UNITED STATES  
NUCLEAR REGULATORY COMMISSION  
WASHINGTON, D. C. 20555

NINE MILE POINT NUCLEAR STATION, UNIT NO. 1

AMENDMENT TO FACILITY OPERATING LICENSE

Amendment No. 47  
License No. DPR-63

Figure 3.1.7a MAXIMUM ALLOWABLE AVERAGE PLANAR LHGR APPLICABLE TO 8DB250 FUEL AS DESCRIBED IN REFERENCE 8.  
Amendment No. 31, 41, 47

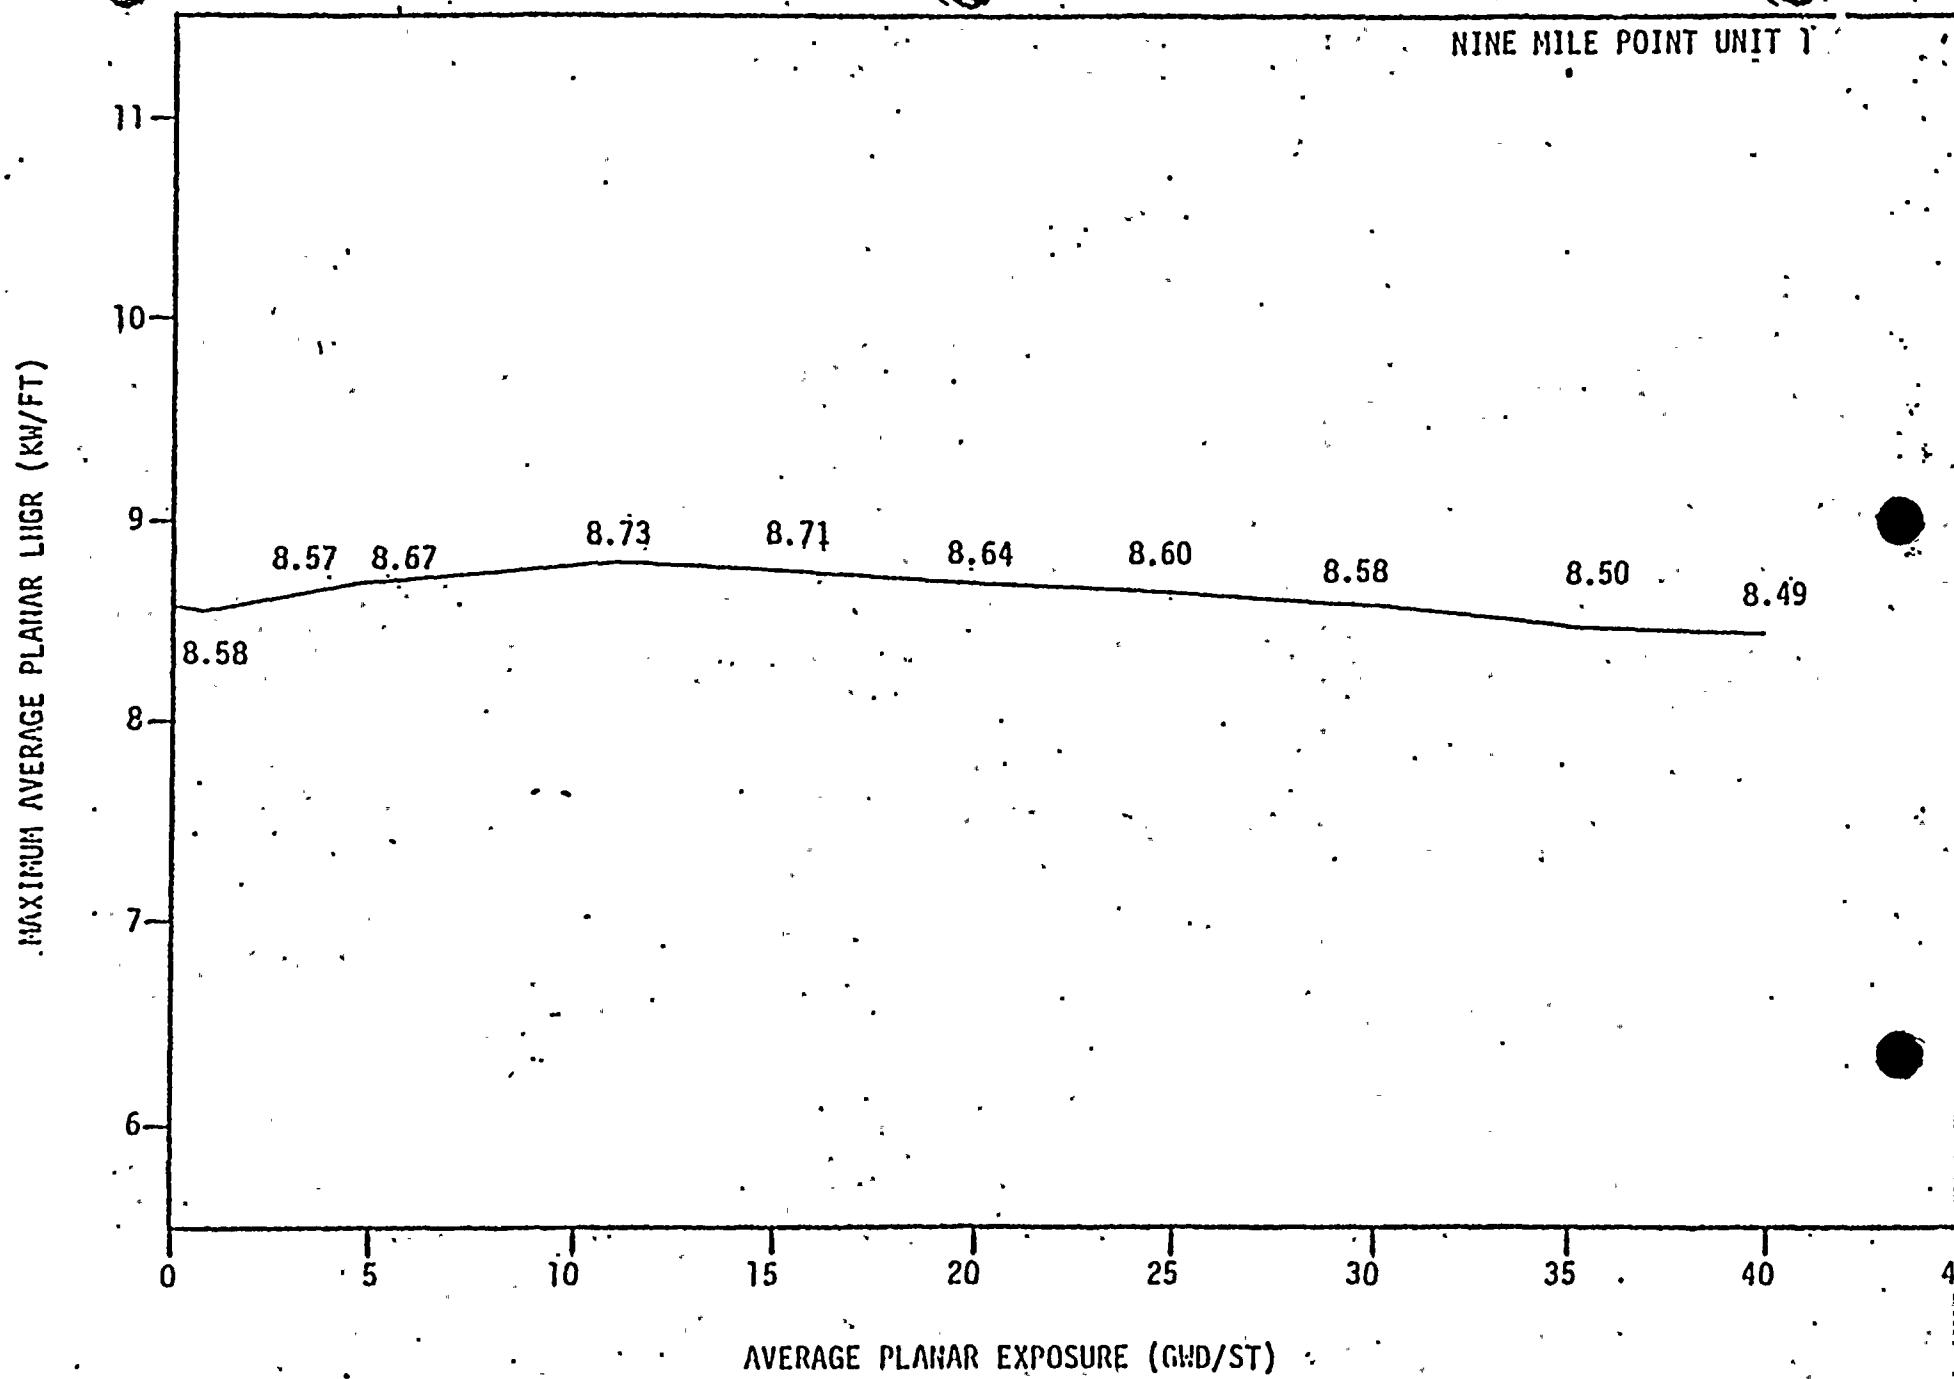
When operating with four recirculation loops in operation and the remaining loop unisolated, the reactor may operate at 100 percent of full licensed power level in accordance with Figure 3.1.7aa and an APLHGR not to exceed 98 percent of the limiting values shown in Figures 3.1.7a, 3.1.7b, 3.1.7c, 3.1.7d, and 3.1.7e.

When operating with three recirculation loops in operation and the two remaining loops isolated or unisolated, the reactor may operate at 90 percent of full licensed power in accordance with Figure 3.1.7aa and an APLHGR not to exceed 96 percent of the limiting values shown in Figures 3.1.7a, 3.1.7b, 3.1.7c, 3.1.7d, and 3.1.7e.

To assure peak clad temperatures remain below 2200°F, analysis has shown that the limiting average planar linear heat generation rate for each fuel type shall be reduced 2 percent and 4 percent for 4 and 3 loop operation respectively (Reference 13).
